Opinion on the Children's Hospital Redevelopment Project

By Anton Dubrau

View from West

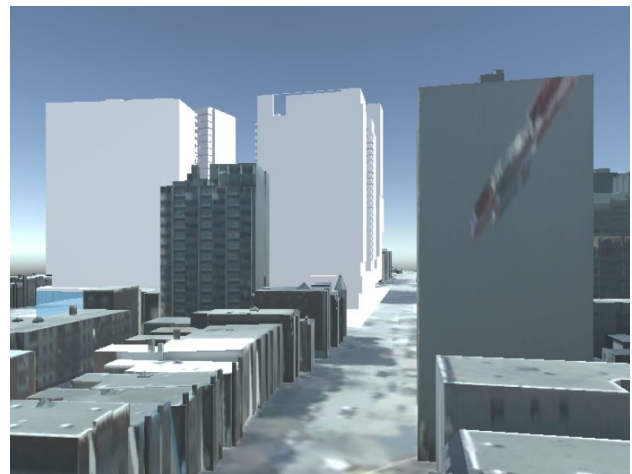
In reality, the extreme height of the condo-buildings will undo some of the supposed environmental friendliness. The higher buildings are, the more energy they require per square meter of usable space, compared to midrises. This is true both for the original construction as well as the maintenance.

At the same time, the buildings are too large, not human scale at all. For people to want to live in the area, the city needs to provide a good quality of life. Large towers are antithetical to that. Given the large height of the buildings, we will miss the goal of building a sustainable, human-scale city that is friendly to families.

View from North

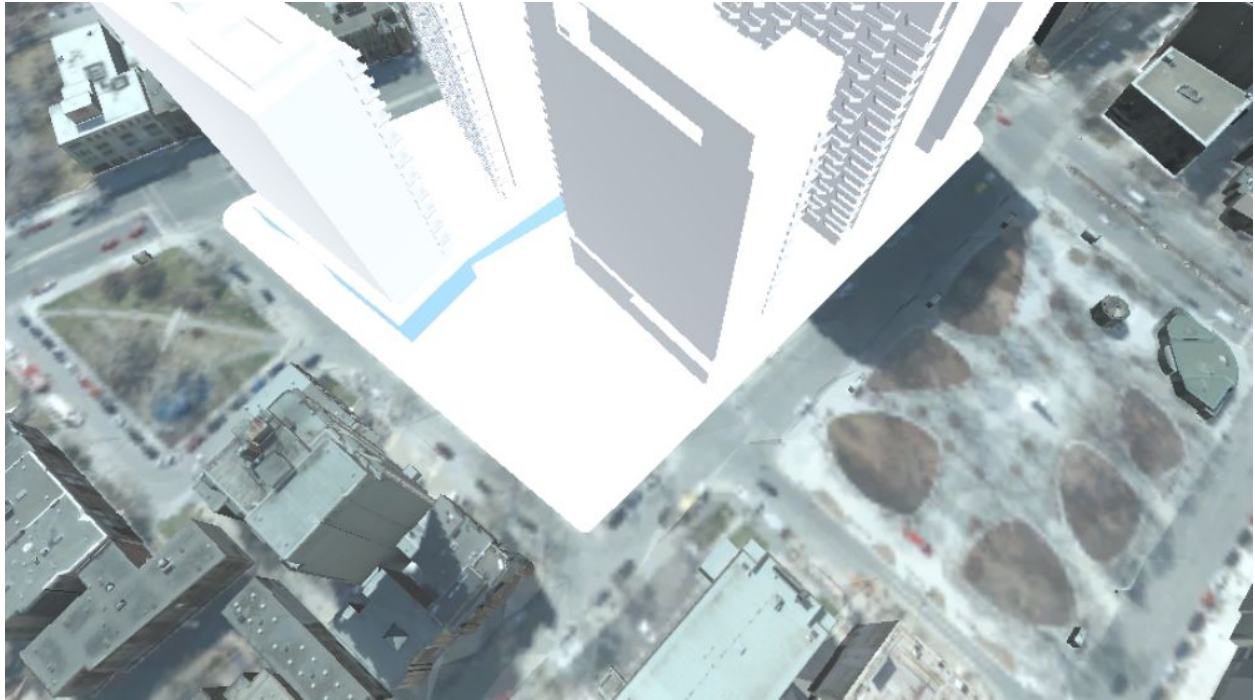
We were told there are about 33% green spaces. Looking at the plan, I wonder where those 33% are. It looks only like about 10% at most, and it's all disconnected. Instead of usable green spaces, we get skyscrapers-in-the park. Or are the concrete areas and the areas on top of the two-storey base counted as green spaces?

Connected downtown park, as proposed by me, constructed by connecting existing, small green spaces and by closing a couple of streets, view from South

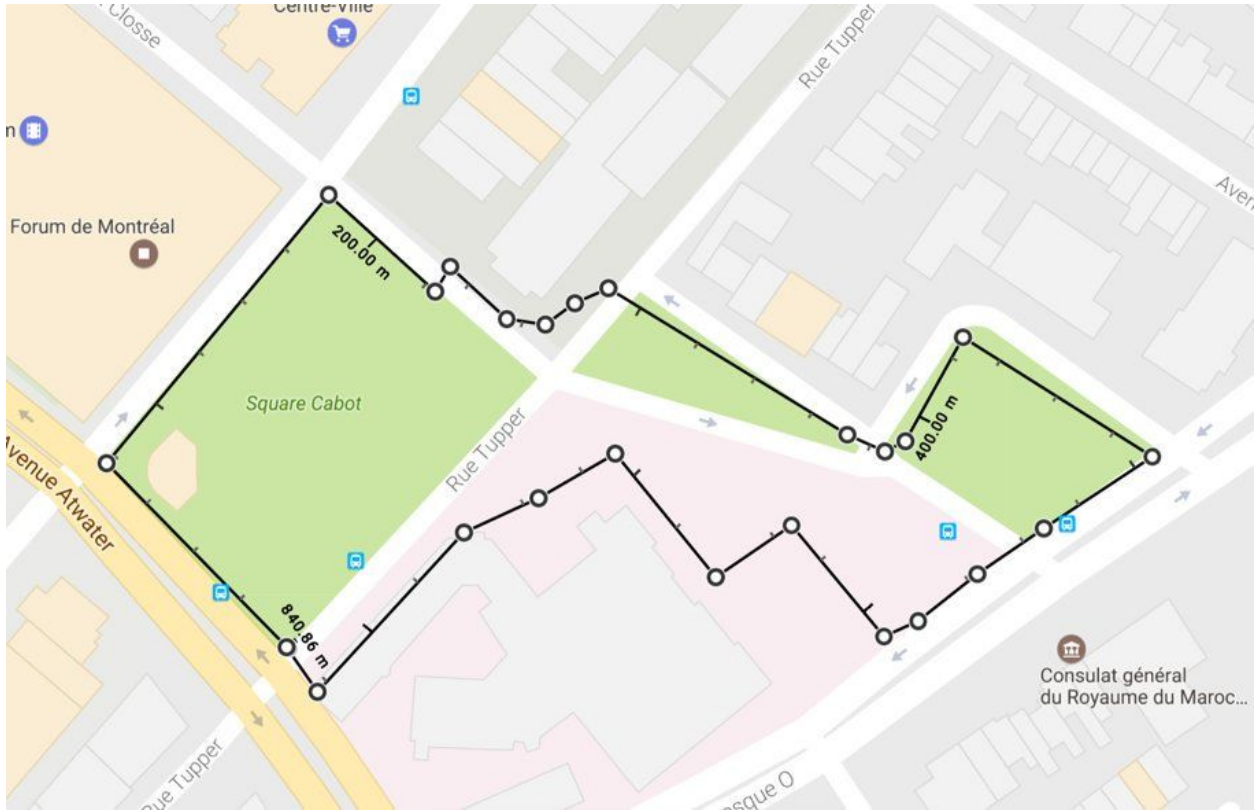
Instead of providing patches of Green in the separation-space of the skyscrapers, we should seize the opportunity the complete reconstruction of the area represents by connecting connecting the three patches of 'park' immediately adjacent to the square (Cabot square, Place Henri-Dunant, Place Hector-Toe-Blake). By using some of the area of the Children's Hospital site and some of the adjacent streets, it is possible to create a continuous, non-trivial park.

Green spaces that are too small simply do not work, they have little to no recreational value. They do not act as an oasis in the city. Visitors need some amount of space large enough that actually provides some separation from the surrounding traffic, in order for it to work. This could bring back some of the necessary human-scale and quality of life back to the area.
